**CALIFORNIA COASTAL COMMISSION**

**M 9e****RECORD PACKET COPY****STAFF REPORT: REGULAR CALENDAR****APPLICATION NUMBER:** 5-02-087**APPLICANT:** Department of Transportation (Caltrans)**AGENT:** Stephanie Reeder, Aziz Elattar, Ron Kosinski; Stefan Galvez**PROJECT LOCATION:** Lincoln Boulevard: between Loyola Marymount University (LMU) Drive (formerly Hughes Terrace) and Fiji Way, Playa Vista, City of Los Angeles; Los Angeles County.

**PROJECT DESCRIPTION:** Widen Lincoln Boulevard to seven lanes north of LMU Drive and to eight lanes between LMU Drive and Jefferson Boulevard (between LMU Drive and Bluff Creek Drive transition from 7 to 8 lanes). North of Jefferson Boulevard, restripe Lincoln to six lanes between Jefferson Boulevard and Fiji Way; north of Ballona Creek add up to ten feet on eastern side of Lincoln within right-of-way. South of Jefferson Boulevard, add a separate bike/pedestrian path on west side of Lincoln between Bluff Creek Drive and Jefferson Boulevard, a sidewalk on east side of Lincoln between LMU Drive and Jefferson Boulevard, widen 5' shoulders on both sides of Lincoln Blvd. to accommodate bicycles; and improve bus stops on both sides of road. Project requir

EXHIBIT NO. 4
APPLICATION NO.
5-02-87
<i>Revised profile</i>

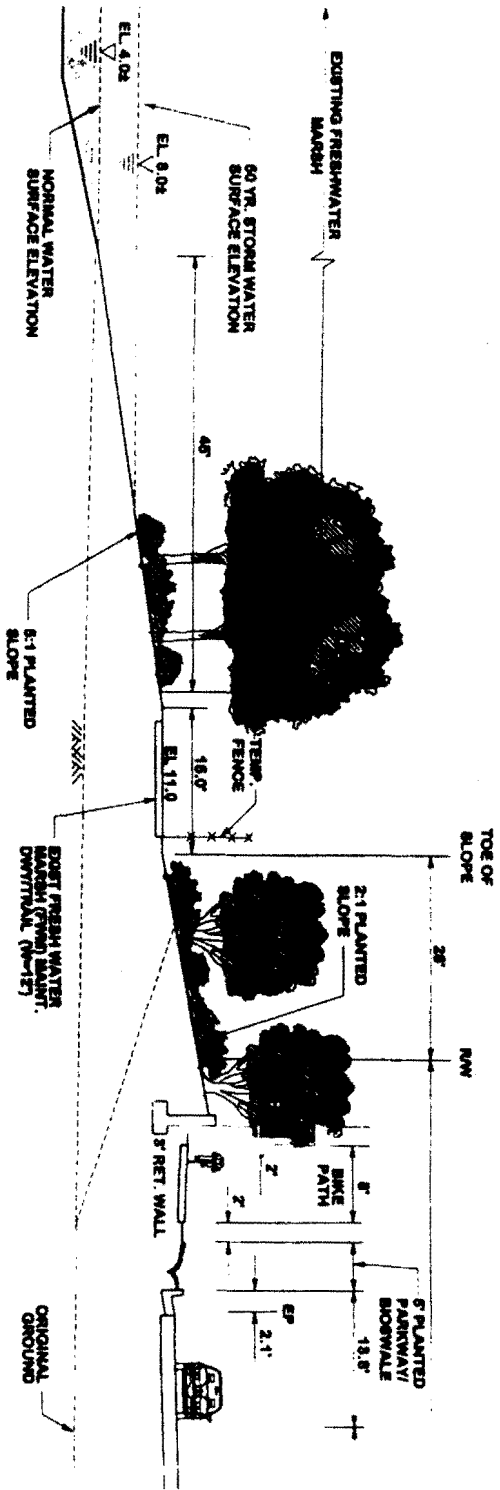
At the February, 2002, Commission hearing, several Commissioners raised questions concerning alternative transportation, and concerns that physical roadway improvements also include widening of bus and bicycle lanes. In response to this, the applicant has changed its project to accommodate other transportation modes. It has added bus stops along both sides of Lincoln Boulevard, an off street recreational bicycle/jogging trail and on-street commuter bicycle lanes. (Exhibits 1, 4-7)

A second issue is noise from Lincoln. Noise studies quoted in environmental documents usually show that highways are very noisy. For example, single-family houses are about half to two thirds as noisy as a high-speed highway. In response to this issue, the applicant has proposed to construct a low wall or a berm between the roadway and the edge of the marsh. The berm will be elevated about 3 feet above the level of the bicycle/jogging path and located between the bicycle/jogging path which is slightly above the level of the road, and the marsh. The berm should reduce the sound of the road, since sound (and light) travel in straight lines. This will not completely shield the marsh from the noise of the road because Lincoln Boulevard and the bike/jogging path are higher than the marsh on the south end of the marsh, where the road cuts through the 70-foot high Westchester bluffs. Nevertheless, along most of the length of the marsh, the three-foot berm, or a small sound wall will protect the marsh from noise and light from Lincoln. (See Exhibits 1, 4, 5, 6 and 7.)
